REMARKS

The above amendments are made in response to the first Office Action mailed February 21, 2003, wherein:

FIG. 2

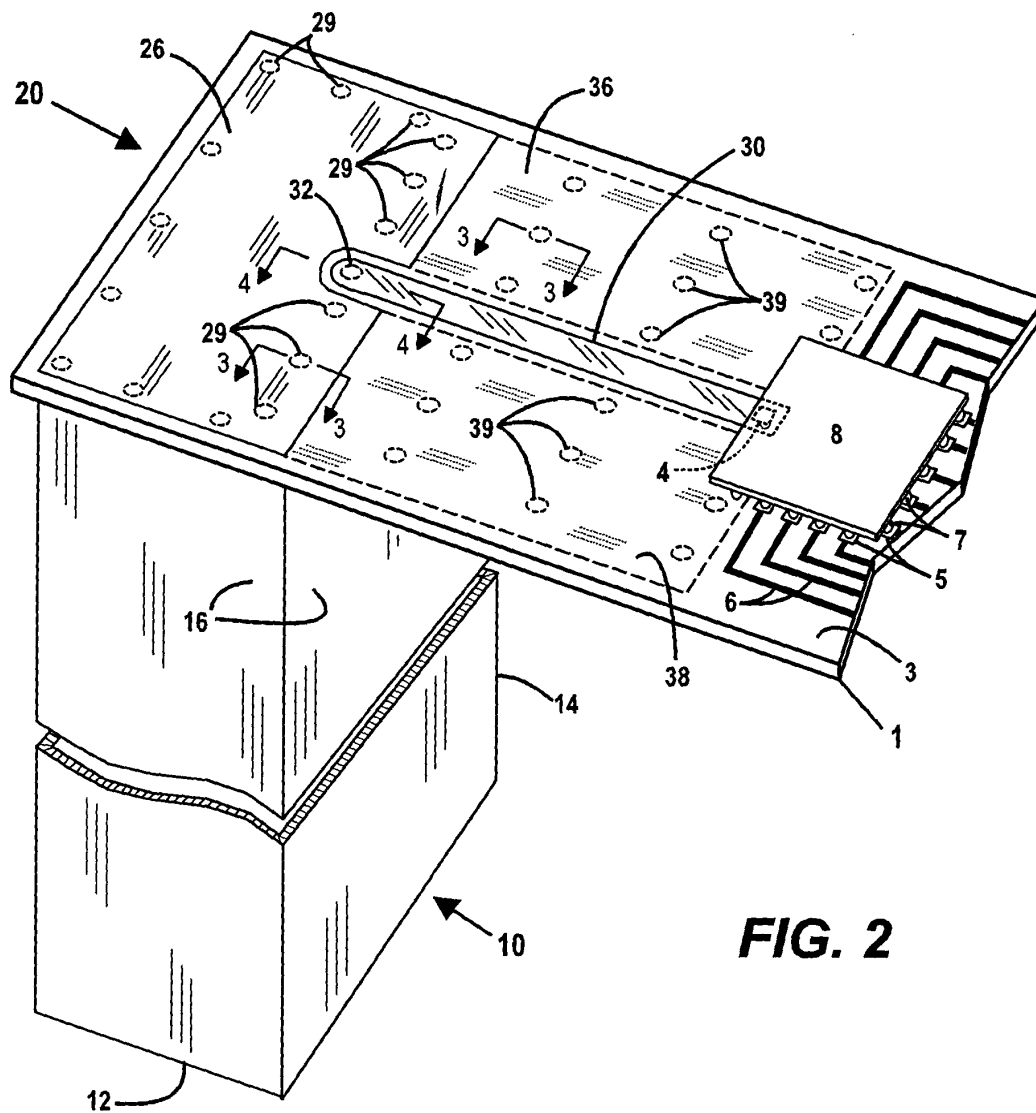
FIG. 2: 12, and 14.

Applicants respectfully submit that reference number 50 was described with respect to FIG. 1 at page 4, lines 28-29 of the Specification as originally filed. With the Amendment, the Specification has been amended to include these reference numbers at points where the figures are described. In addition, FIG. 5 has been amended to change the reference number 20 to 20' so as distinguish the different configuration of the capacitive diaphragms 28' and 28". In addition, the Specification has been amended to address the other objections noted by the Examiner.

FIG. 3

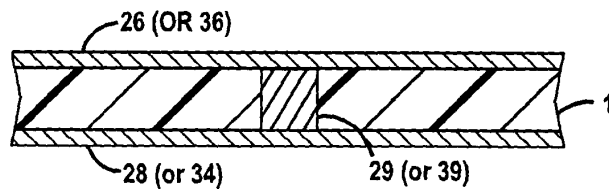
FIGS. 3 and 4: 26, 28, and 34.

FIG. 3: 39.

FIG. 4

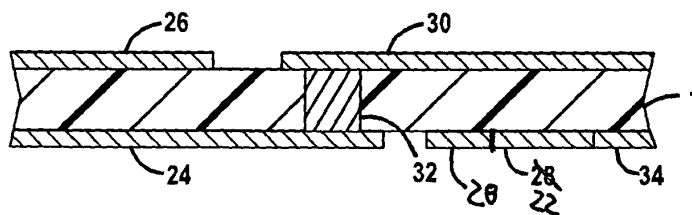
FIG. 4: 1, 24, and 30.

FIG. 8

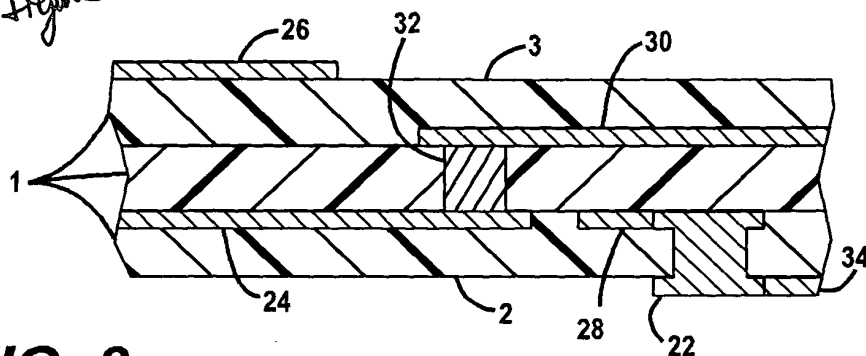
1. the disclosure was objected to for a number of informalities;
2. the drawings were objected to under 37 CFR 1.83(a) for not showing every recited feature of the claims;
3. Claims 2, 4, and 14 were rejected under 35 U.S.C. § 112, second paragraph, for being indefinite;
4. Claims 1, 3, 6, 7, 10-13, 15, 18, and 20 were objected to for various reasons;
5. Claims 1, 2, 5, 2, 8, 10, and 11 were rejected under 35 U.S.C. § 102(a) as being anticipated by published French patent application No. 2,462,787 to Crochet (the "Crochet Application");
6. Claims 3, 4, 9, 12, and 13-17 were rejected under 35 U.S.C. § 103(a) as being obvious over the Crochet Application considered alone; and
7. Claim 6 was rejected under 35 U.S.C. § 103(a) as being obvious over the Crochet Application in view of U.S. Patent Nos. 5,585,768 to Wei (the "Wei patent").

*Added
Figure*
